Amendment No. 9

Construction – Building A

SOLICITATION NO. : 201801002

**ADDENDUM N°** M02

2. DRAWINGS**2.1 Drawing M100**

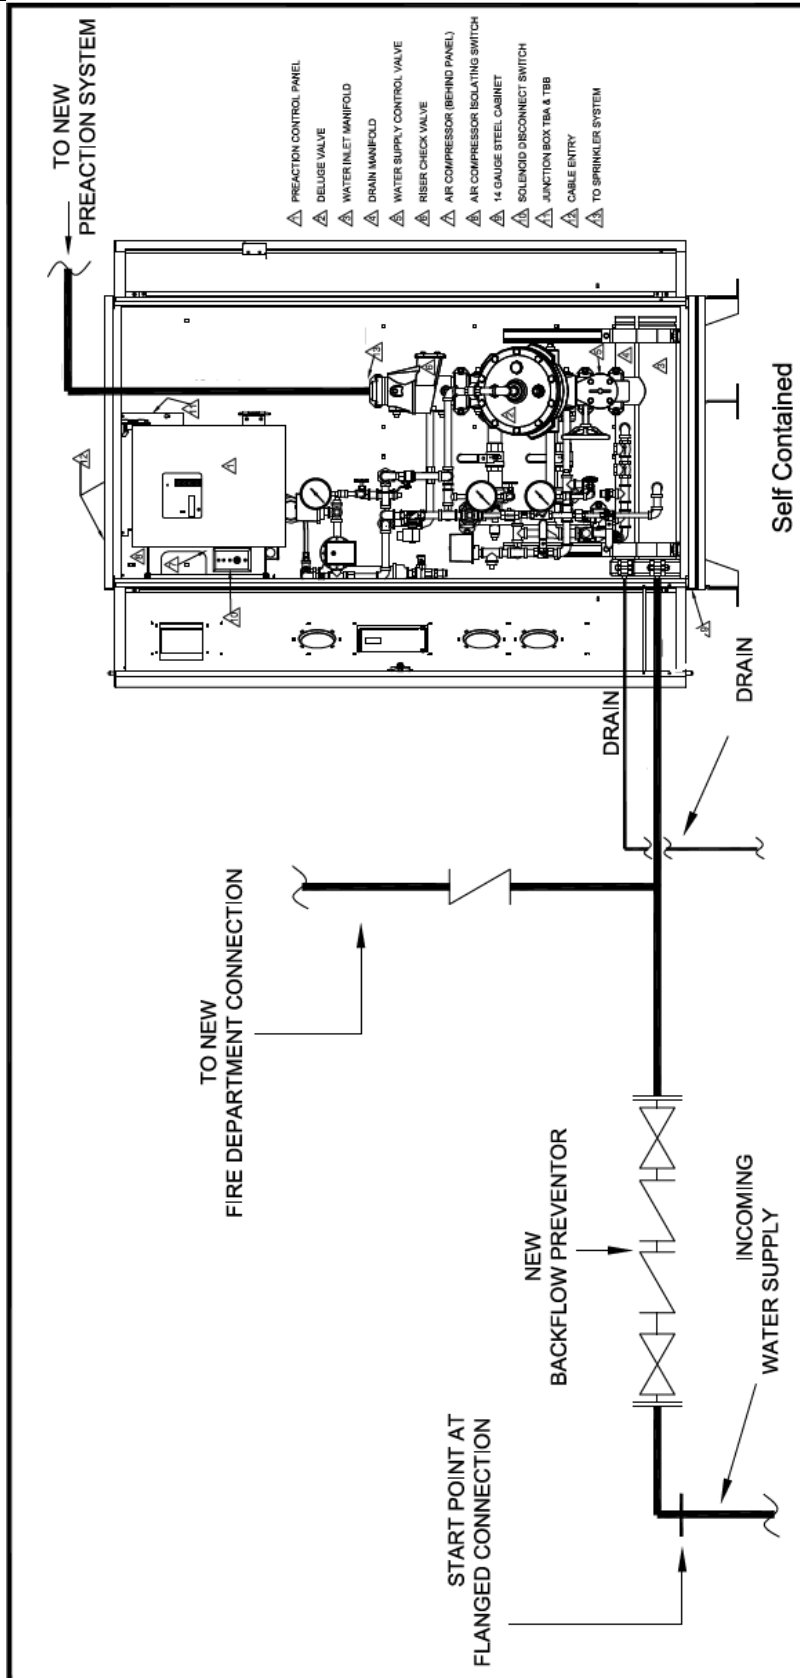
- 2.1.1 General note 2; modify "NFPA 14" to read "NFPA 13".
2.1.2 Add the pre-action schematic on the following page to the drawing.

2 FIRE ALARM SCHEMATIC DIAGRAM
NOT TO SCALE

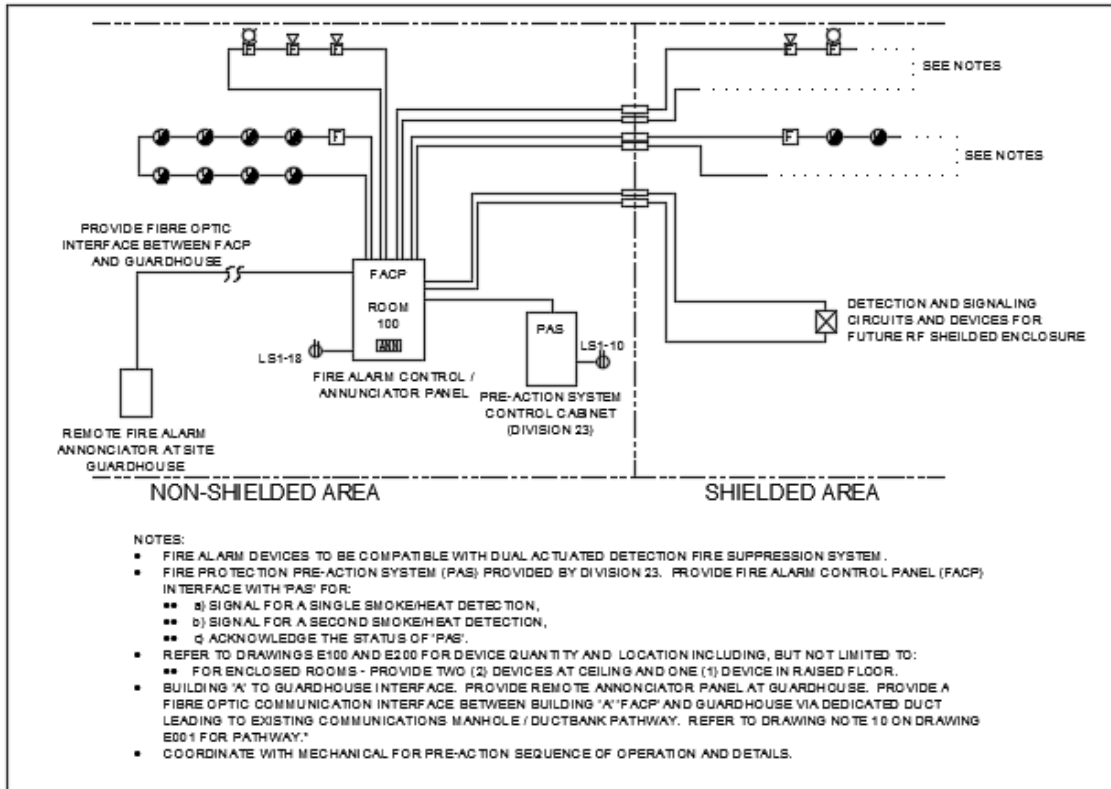
Q5: Fire Alarm schematic on drawing E002 shows the following:

- Fire Extinguishing Control Panel.
 - Are there specifications on this panel? What is it for? Are we supplying it?
- Remote fire alarm monitoring at site guardhouse.
 - Is this ULC S561 remote monitoring equipment or is it a remote fire alarm annunciator for the guard house?

7. Locate panel 'ELS2': REPLACE text to read 'LS2'.
8. Locate detail '2', REPLACE entire detail with the following detail:

A5: Fire Extinguishing Control Panel (FECP): supplied by division 23/24. Fire Alarm Control Panel (FACP) interface for alarm/trouble notification from the FECP. Remote Fire Alarm Annunciator is

required for the Guard house to monitor & control Building A fire alarm/trouble status. (CIMA)
